Submission to the NSW Major Project portal regarding Lourdes Retirement Village, Killara (SSD-88004956).

Figure 1: Visual impact and distance information (refer to points 1.2 and 1.3 for explanations)

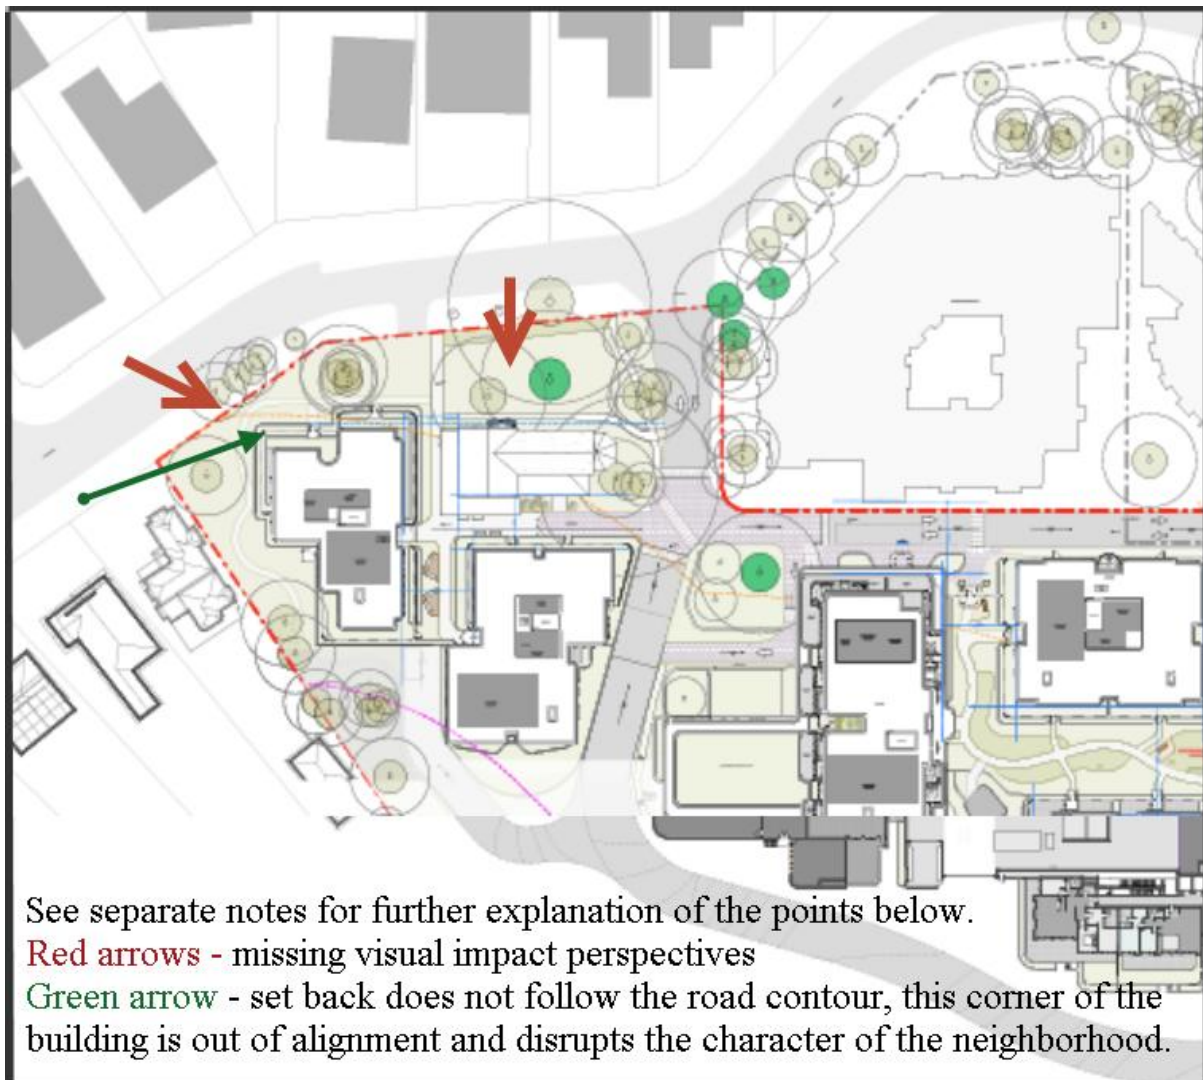
The two views are marked on the screenshot in Figure 1 (screenshot taken from the architectural drawings supplied with the development submission).

RED arrows on Figure 1 show views that are needed:

- 1.2a) A view directly from Stanhope Road toward Headfort House that will show how much Building J is visible behind Headfort House.

Based on the information in the plans, it seems that no new trees would be planted between Headfort House and Building J – and with Building J significantly higher than Headfort House, it seems there would be a significant visual impact. This view should be made explicit/clear.

- 1.2b) A view toward the village from an angle representing views from the direction of the house on the Northeast corner of Roseberry and Stanhope). This view would also represent how the Lourdes village will come into vision for people approaching the area.

1.3) Building I seems more prominent than the existing buildings on both sides, however the full information required to assess the situation is not provided. Importantly, the plan views do not provide dimensions of setbacks from the site boundaries. If this information is somewhere in the many files provided, it has not been easy to find – noting the limited time for review and feedback.

The GREEN arrow in Figure 1 shows an area where more information is needed. Since Stanhope Road angles toward the Lourdes property, the property boundary becomes increasingly closer to Building I, however the dimensions providing detail about the setback don't seem to be available. In particular, the northwest corner of Building I is closer to the boundary than the neighbouring buildings at the location of the GREEN arrow.

Recommendation: Provide further information as requested and allow more time for affected stakeholders to evaluate and respond. A consultation session once the full materials are available would be beneficial.
